**SERVICE
BULLETIN**

1984

1984 Service Bulletin Book

SUBJECT Eccentric Shaft Pulley Modification.

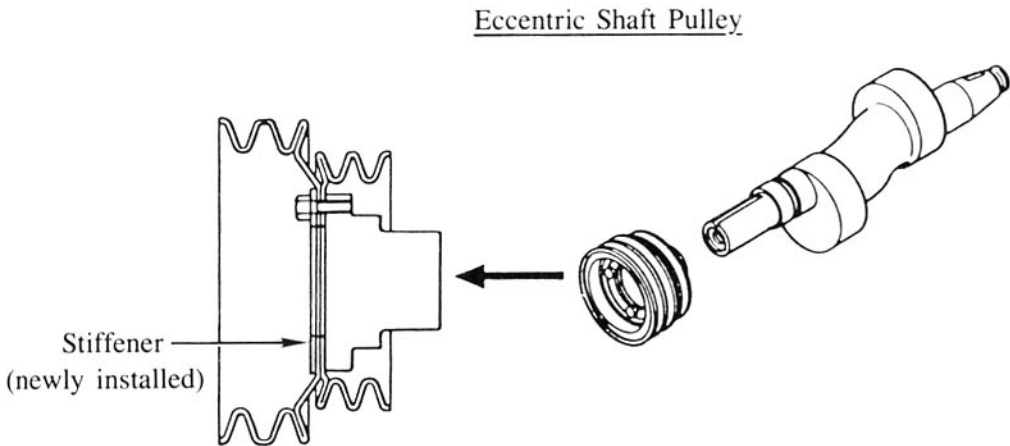
DESCRIPTION A stiffener has been installed on the eccentric shaft pulley since the production date of August, 1984.

| PART NUMBER | | DESCRIPTION | INTERCHANGEABILITY | APPLIED MODEL |
|--------------|-------------|------------------------|--------------------|---------------|
| N249 11 600A | N249 11 600 | Eccentric Shaft Pulley | NEW → OLD | RX-7 12A |
| N304 11 600A | N304 11 600 | Eccentric Shaft Pulley | NEW → OLD | RX-7 13B |

SUBJECT Secondary Air Control System Modification.

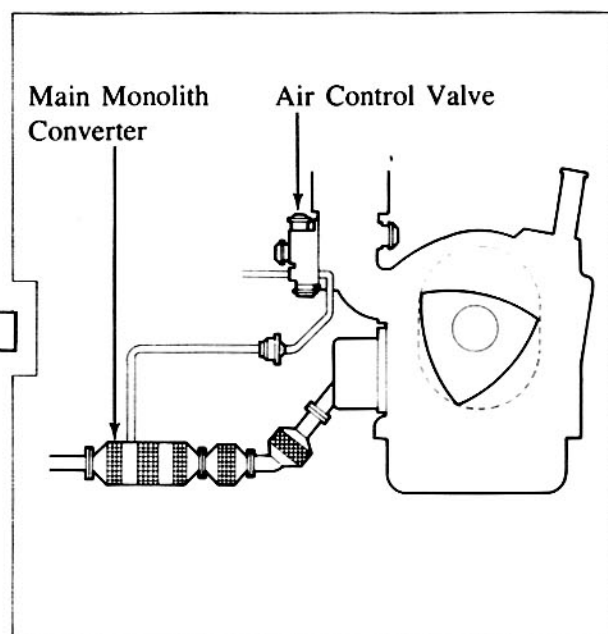
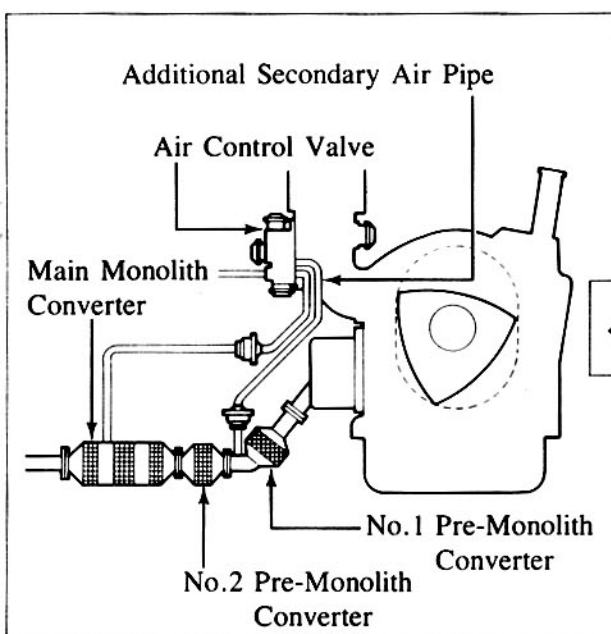
DESCRIPTION The Secondary Air Control System has been modified since the production date of March, 1984.

Now air is injected behind the No.1 pre-monolith converter when the Port Air Switching Valve (newly added to the Air Control Valve) is open. Port and split air operation remain the same as previous years.

The Port Air Switching Valve will open between 3,000-4,000 rpm or above 50 mph.

Newly Established

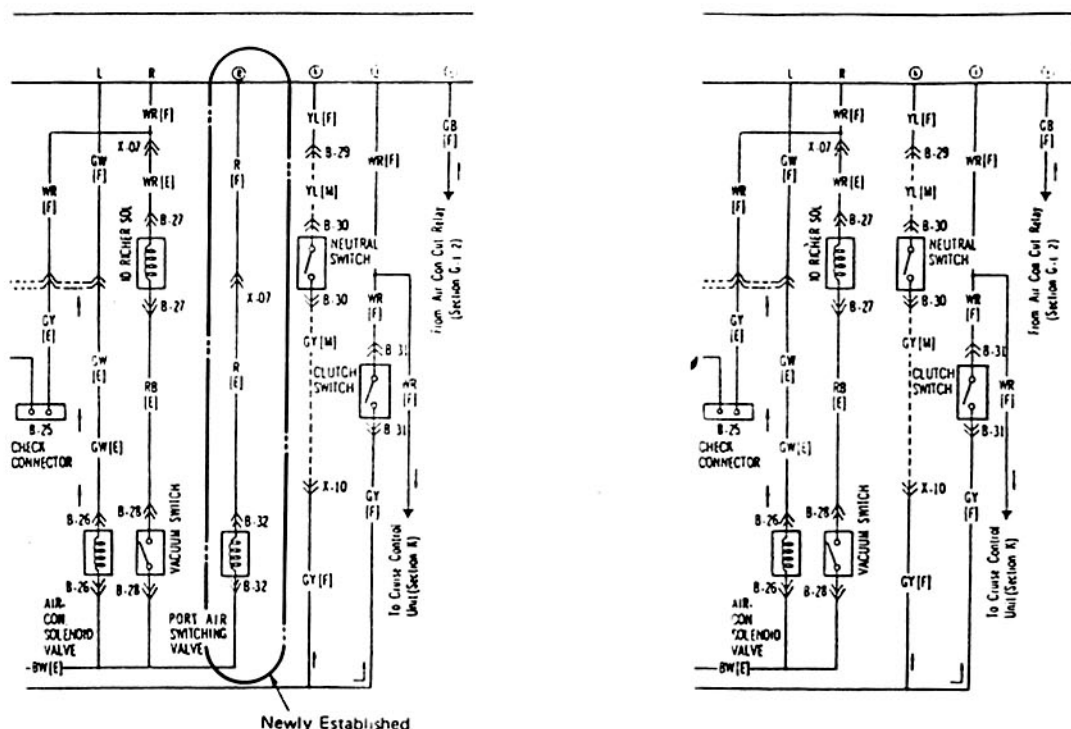
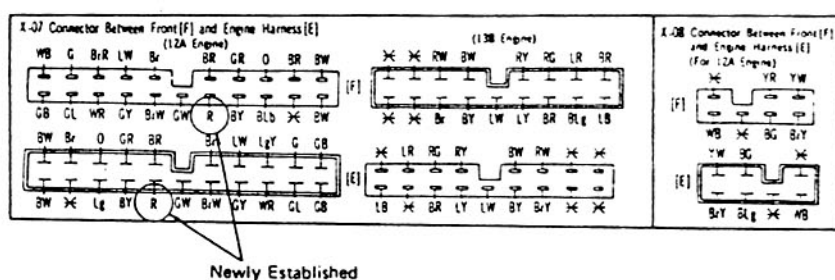
Due to the addition of the Port Air Switching Valve in the Air Control Valve the wiring harness has been changed as shown below.

SUBJECT Modification of Bearing Cover Bolts.

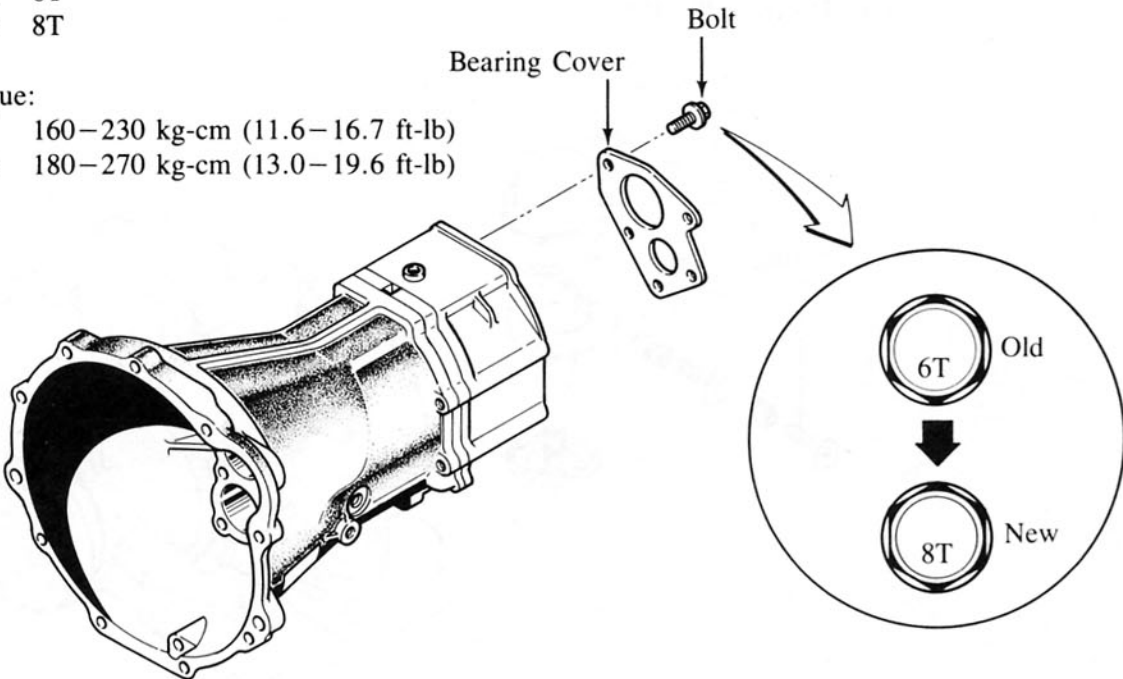
DESCRIPTION The bolts attaching the transmission bearing cover have been strengthened and the tightening torque has been increased to improve the durability of the transmission.

- Old: 6T
- New: 8T

- Old: 160–230 kg-cm (11.6–16.7 ft-lb)
- New: 180–270 kg-cm (13.0–19.6 ft-lb)

SUBJECT Transmission Front Bearing Modification.

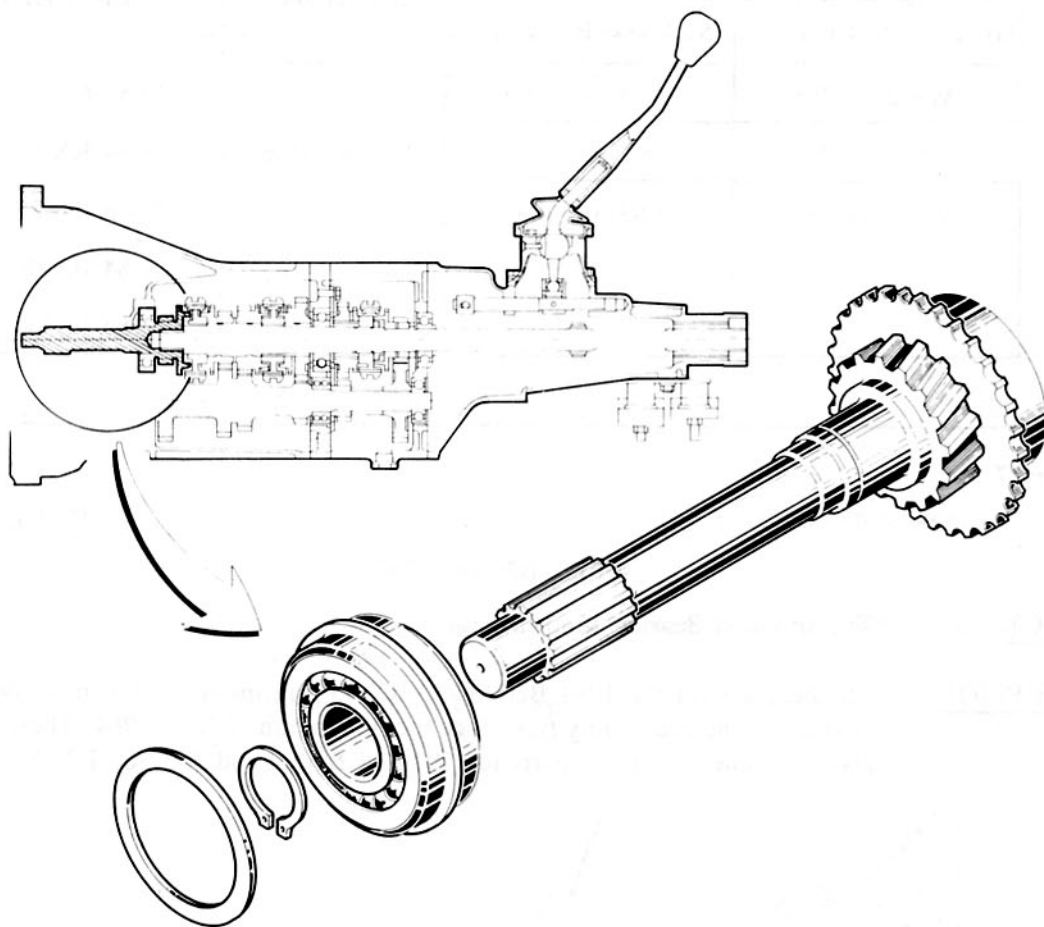
DESCRIPTION The front bearing in the transmission has been changed to a heavy duty type since the production date of January, 1984.

SUBJECT Transmission Bearing Modification.

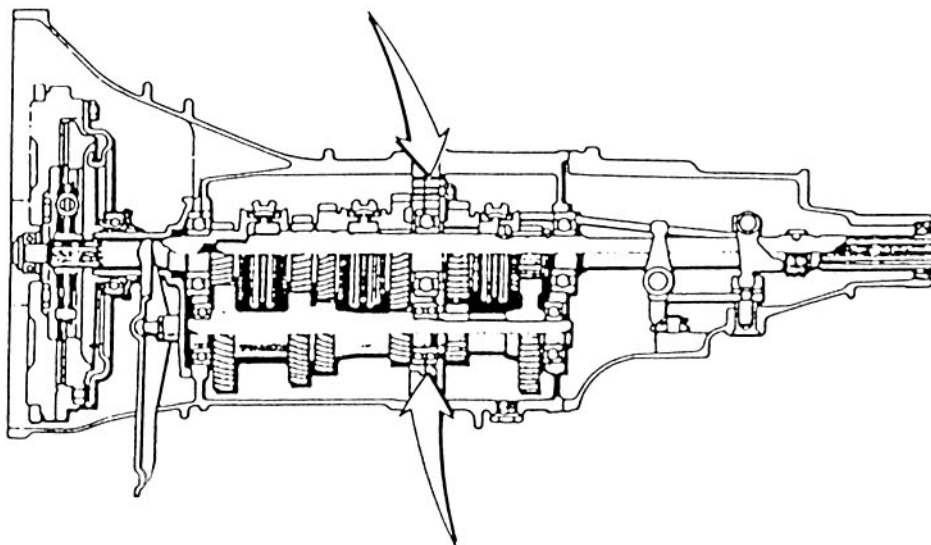
DESCRIPTION The bearings for the 1984 B2000 and B2200 transmission, shown below, have been changed to the heavy duty type since the production of July, 1984. These bearings are also available as service parts for 1979-84 B2000 and 1982-84 B2200.

5th Gear & Counter 5th Gear Modification.

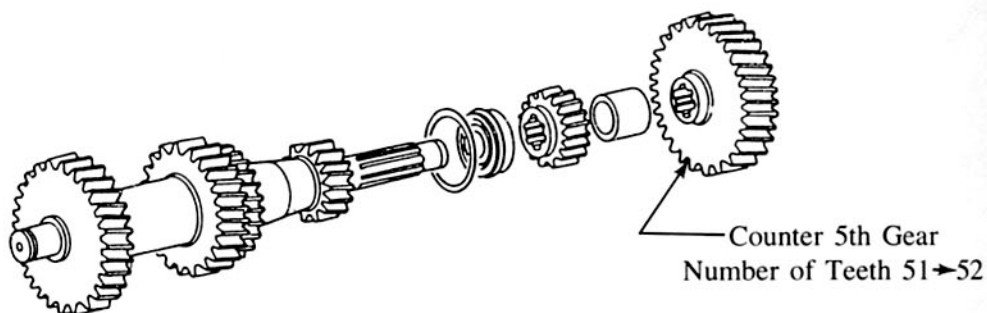
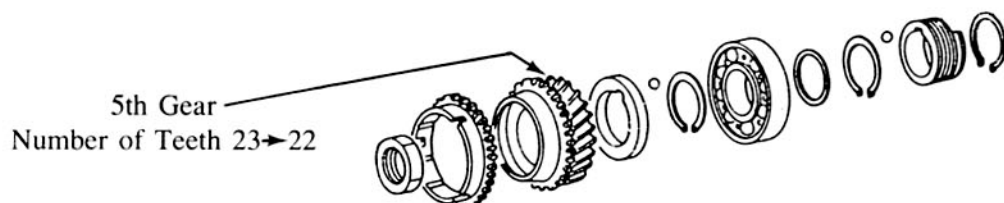
The number of the teeth of the 5th gear and counter 5th gear has been changed since the production date of July, 1984. Because of this change, the gear ratio of the 5th gear has been changed from 0.758 to 0.711.

Correction to Workshop Manuals.

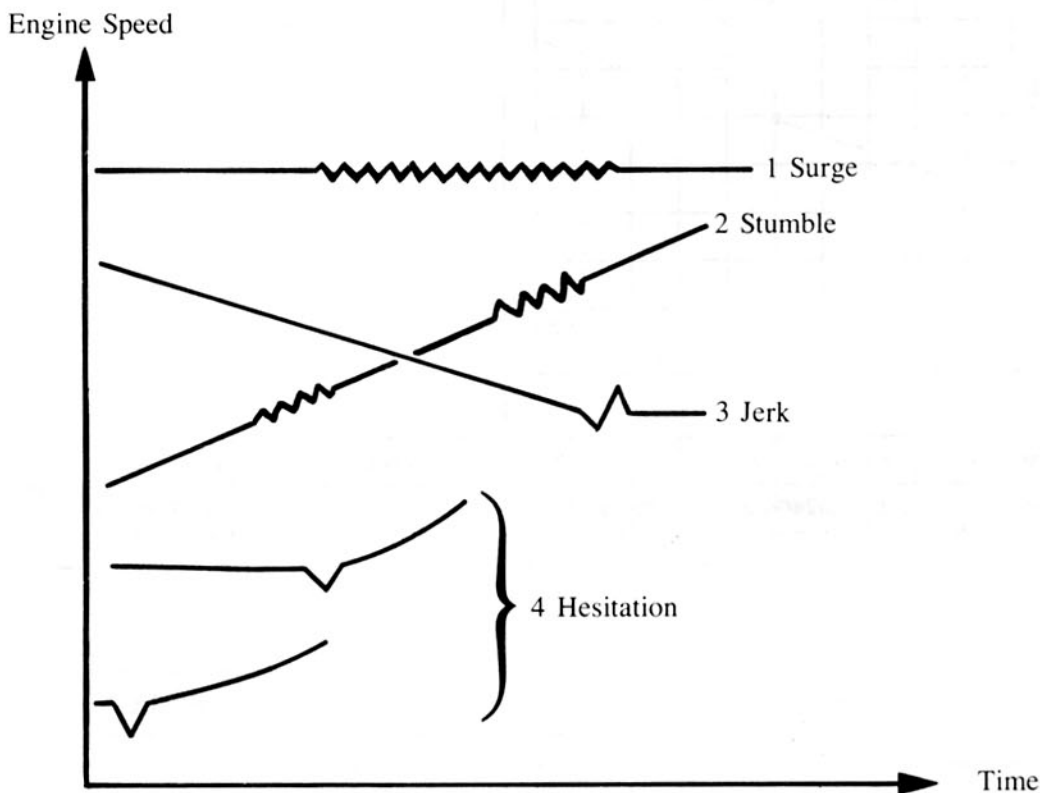
An error has been discovered in the 1982-1984 B2000 Workshop Manuals. Please correct the manuals, page 1A:3, Fig.1A-4 as shown. Self-adhering stickers are provided for this area of the Workshop Manual.

SUBJECT Correction to Workshop Manual.

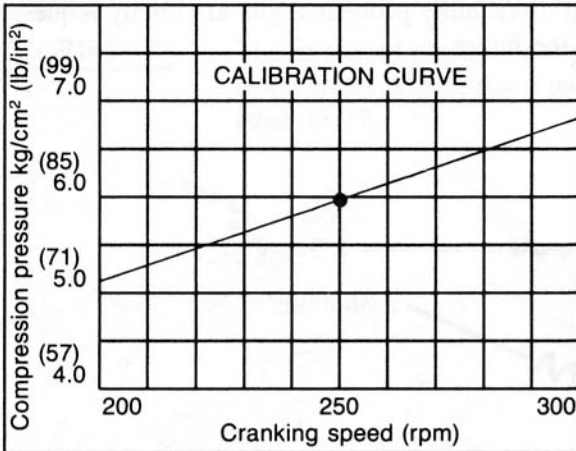
DESCRIPTION Please make the following corrections to the 1984-1985 RX-7 Workshop Manuals, page 1-12. Self-adhering stickers are provided for your convenience.

| CORRECT | INCORRECT | | | | | | | | | | | | | | | | | | | | | | | | | | | | | | | | | | | | | | | | |
|--|-----------|-----|-----|------------|------------|-----------|-----|-----|-----|----|-----|-----|-----|-----|------------|------------|-----|-----|-----|-----|--|-------|----|----|----|-----------|-----------|----|----|----|----|-----|-----|-----|-----|------------|------------|-----|-----|-----|-----|
| <div><table><tr><td>Peaks</td><td>17</td><td>18</td><td>19</td><td>20</td><td>21</td><td>22</td><td>23</td><td>24</td><td>25</td></tr><tr><td>rpm</td><td>204</td><td>216</td><td>228</td><td>240</td><td>252</td><td>264</td><td>276</td><td>288</td><td>300</td></tr></table></div> | Peaks | 17 | 18 | 19 | 20 | 21 | 22 | 23 | 24 | 25 | rpm | 204 | 216 | 228 | 240 | 252 | 264 | 276 | 288 | 300 | <table><tr><td>Peaks</td><td>17</td><td>28</td><td>29</td><td>20</td><td>21</td><td>22</td><td>23</td><td>24</td><td>25</td></tr><tr><td>rpm</td><td>204</td><td>216</td><td>228</td><td>240</td><td>252</td><td>264</td><td>276</td><td>288</td><td>300</td></tr></table> | Peaks | 17 | 28 | 29 | 20 | 21 | 22 | 23 | 24 | 25 | rpm | 204 | 216 | 228 | 240 | 252 | 264 | 276 | 288 | 300 |

Fig.17

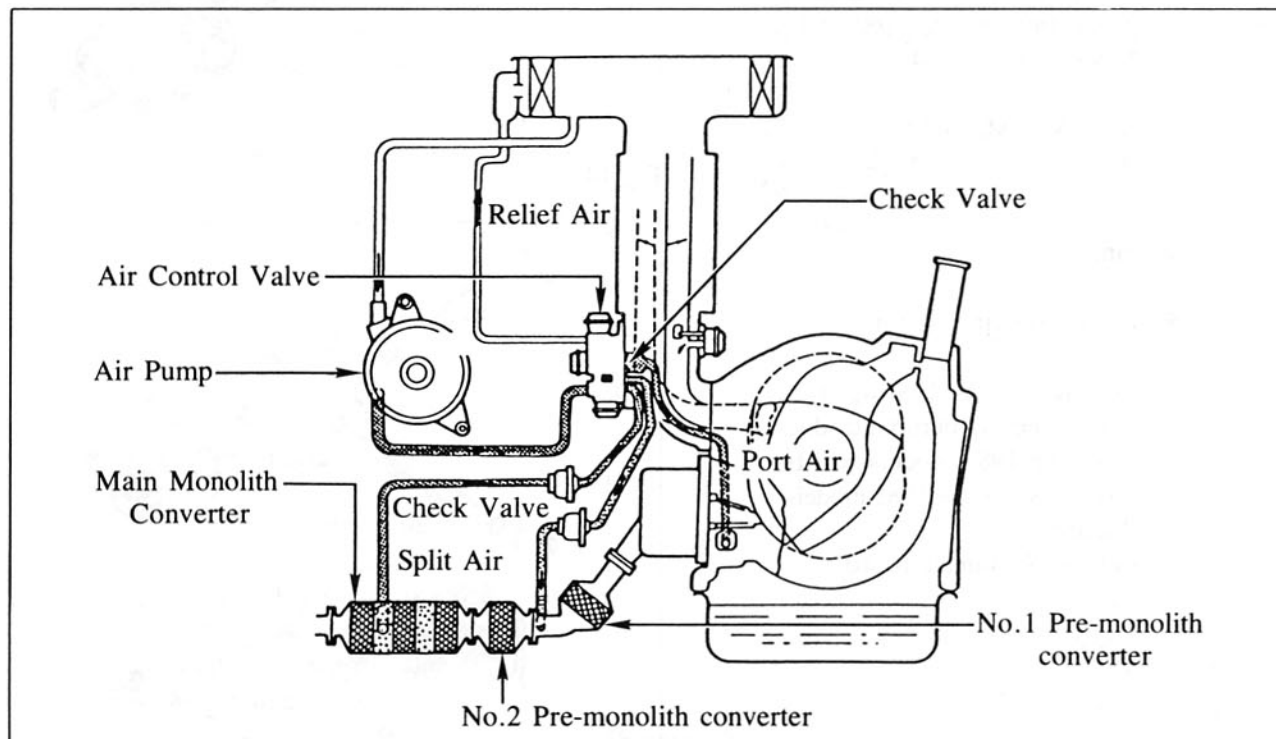
- Air Injection (Figure 17)

The port air switching valve introduced in mid-'84 has been carried over to the 1985 models.
Ref. W/S Manual 4A:18 and 29
